# MIAMI BEACH

### Staff Report & Recommendation

### Design Review Board

SUBJECT: DRB24-1014  
**4-6 Star Island**

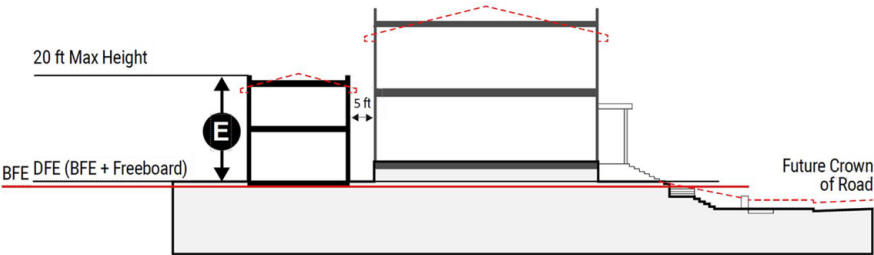
The Applicant is requesting a five (5) foot height variance for the one-story cabana accessory structure at the rear yard. The cabana is proposed at a height of 17 feet and 9" which exceeds the maximum height of 12' for a one-story accessory structure. It is important to note that for accessory structures, the height is measured from base flood elevation plus one foot of freeboard. When facing a waterway, the minimum setback for a one-story accessory structure is one half of the required rear setback. In contrast, the minimum required setback for a two-story accessory structure along an interior side yard is 10 feet or the required side yard setback. The rear setback for a two-story accessory structure consists of one half of the required rear setback or 15', whichever is greater.

Staff is supportive of the height variance due to the proposed accessory structure complying with the greater setback requirements of a two-story structure. The lush landscaping along the side yard is set partially on a lower terrace than the pool and therefore minimizing the height in relation to the pool. Consequently, the granting of the variance requested will not confer on the applicant any special privilege that is denied by these land development regulations to other lands, buildings, or structures in the same zoning district. While staff has no objection to the granting of the proposed variance, pursuant to Article I, Section 2 of the Related Special Acts, the maximum height variance that can be approved by the board is three (3) feet. As such, staff recommends that the variance be approved, not to exceed 3 feet.

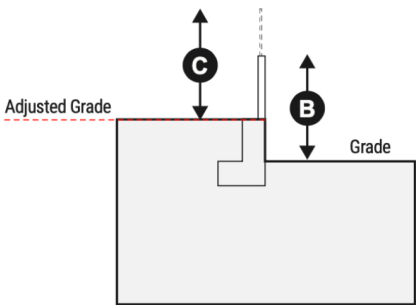
Variance #8 is related to a fence along the interior south side yard proposed at 12'-6" from the grade elevation of 5'-6" NGVD where the maximum height allowed is 7'-0". In the past, the height of the fence, measured from grade elevation has been associated with variances when the grade of the property is very low. The Code has been modified to allow the interior side fence to be measured from future adjusted grade, which is a higher elevation than grade, provided that the portion of such fences, walls or gates above 4 feet in height consists of open pickets with a minimum spacing of 3 inches. Additionally, landscaping can be utilized to screen the property more fully. Based on this analysis, staff recommends denial of variance #8. However, if the Board decides to approve the variance, staff recommends limiting the variance to a height of 10' from grade elevation so that it is consistent with Article I, Section 2 of the Related Special Acts of the City Charter, which states that height variances of greater than 3 feet cannot be granted.
